# Access Compliance Report

## Public Rights-of-Way

Intersection ID: 28624	Main Street: PEDLAR_MILLS_RD	Cross Street: STUARTS_DRAFT_CT	Location: NW
ADA ID: C6D24E836FC2	Ramp Type: PerpDiag	Initial Pass/Fail: Pass	Overall Compliance: No
Severity Score: 10			
Codes/Mitigation Info/Possible Solution		Field Measurements/Component Compliance

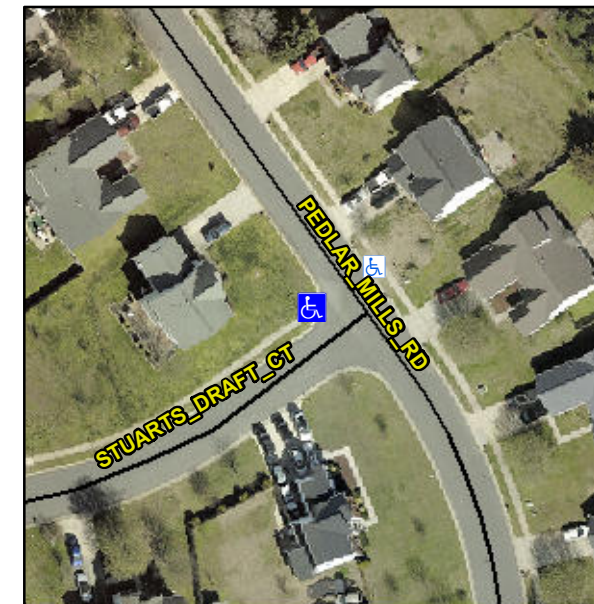
**Remove & Replace Curb Ramp With Two New Directional Ramps or Equivalent.**

**R304.2.1, R305**
